RE: Osage Second Plat

We are responding to your comments dated June 9, 2021 and are submitting with this letter revised plans. Please find the original comments below, our responses are below in bold italics.

Final Plat Comments

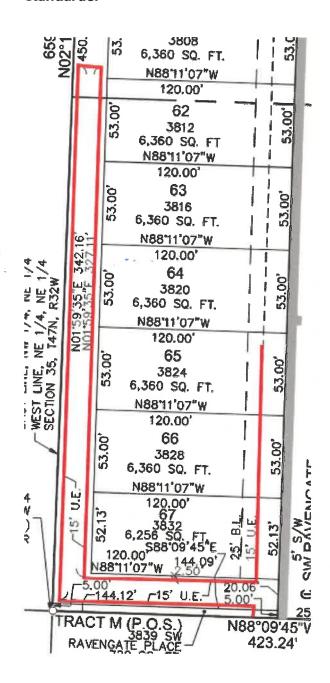
1. Please correct the spelling of the Planning Commission Secretary, it should read Cynda A. Rader.

The correct spelling of Cynda A. Rader has been added on sheets 1 and 2. The June 2, 2021 was displayed as Cynda A. Radar and this submittal now reads Cynda A. Rader.
